SCHEMATIC DESIGN | MARCH 3, 2023

Broadway Field Renovation

Seaside, Oregon

Preliminary City Review

Site Key

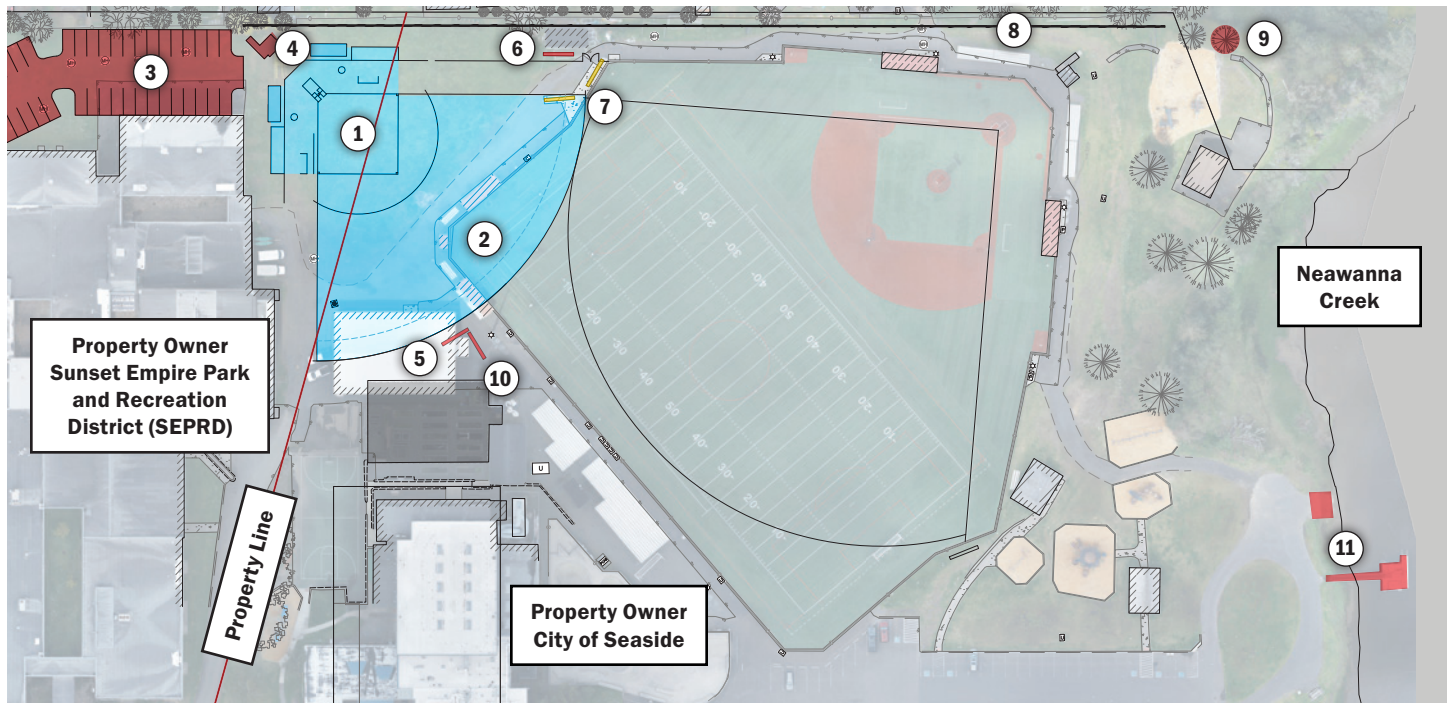
- 1. City Staff Comment (Fire):** Turn around for FD apparatus. Dead end over 150 feet. Area needs to be striped as seen. White lettering, NO PARKING FIRE LANE.

- 2. City Staff Comment (Fire):** Fire Lane, White lettering, NO PARKING FIRE LANE.

- 3. City Staff Question (Fire):** How will the north goal post be installed? Currently done by crane.

- 4. City Staff Question (Fire):** How will the west light posts be serviced? Currently done by power company bucket truck.

5. **City Staff Question (Fire):** What will the load capacity be for vehicles? (Emergency response).

6. **City Staff Comment (Fire):** FD padlock on gate.

7. **City Staff Comment (Fire):** Area needs to be striped as seen. White lettering, NO PARKING FIRE LANE.

8. **City Staff Comment (Planning):** Since the locker rooms are being removed from the project it would be worth mentioning the restroom facilities in the Herche building will be open for softball use.

9. **City Staff Comment (Fire):** There are concerns on the load capability of the turf field and the ability to drive vehicles on it for emergencies and for maintenance of the lighting and other systems.

Applicant Response: The comment pertains to portions of the proposed northern parking lot. The parking stall configuration has been revised and red fire lane striping has been incorporated into the preliminary site plan. Final configuration and details will be coordinated with the fire department as design progresses.

Applicant Response: The comment pertains to portions of the proposed northern parking lot. Red fire lane striping has been incorporated into

the preliminary site plan. Final configuration and details will be coordinated with the fire department as design progresses.

Applicant Response: Per the turf manufacturer, removable field goal posts on synthetic turf fields are frequently installed using rubber-wheeled reach forklifts or scissor lifts that do not damage the synthetic turf during installation.

Applicant Response: Per the lighting manufacturer, the proposed luminaires will be LEDs rated for roughly 100,000 hours rather than traditional halogen bulbs and therefore no access to the top of the poles is anticipated to be required for the lifecycle of the new synthetic turf field. The primary maintenance item are the LED drivers that are located in a pole-mounted cabinet situated roughly 10 feet above grade which can be accessed via ladder or small lift. In the event of premature LED failure or unanticipated required maintenance, turf protection measures as required by turf provider such as mats or plywood sheeting will be installed, and an appropriately sized maintenance vehicle driven on the field. A telescopic boom lift or similar equipment is then used to access the lights.

Applicant Response: The new pavement section in the north parking lot will be designed to support a fire apparatus weighing up to 75,000 pounds as required by Oregon Fire Code Appendix D, Section D102.

Applicant Response: The comment pertains to the existing gate on the southern emergency access route between the two SEPRD buildings. The gate will be provided with a, emergency services-approved Knox lock if one does not exist today.

Applicant Response: The comment pertains to the southern emergency access route between the two SEPRD buildings. This area is a fire lane today and portions are currently striped accordingly. Existing fire lane striping will be refreshed and additional striping added as necessary. Final striping configuration and details will be coordinated with the fire department as design progresses.

Applicant Response: The locker rooms are being removed from the CUP application but are still planned to be included with future improvements to the SEPRD facility. The Herche building restrooms have been called out on the site plan and temporary portable restrooms have been added that are proposed to be in place until future SEPRD facility upgrades are completed.

Applicant Response: Typically, injured players are shuttled off the field using a gurney or small utility vehicle. If a severe injury or other unforeseen circumstances arises, the synthetic turf field can be driven on by an ambulance or other emergency vehicle. The turf is underlain by a compacted aggregate section similar to gravel parking lots and roadways, and the turf manufacturer has not seen an ambulance cause an issue when driving on a synthetic turf field. Should an emergency vehicle damage the synthetic turf, the turf will be maintained or repaired as necessary to ensure a safe playing surface is maintained.
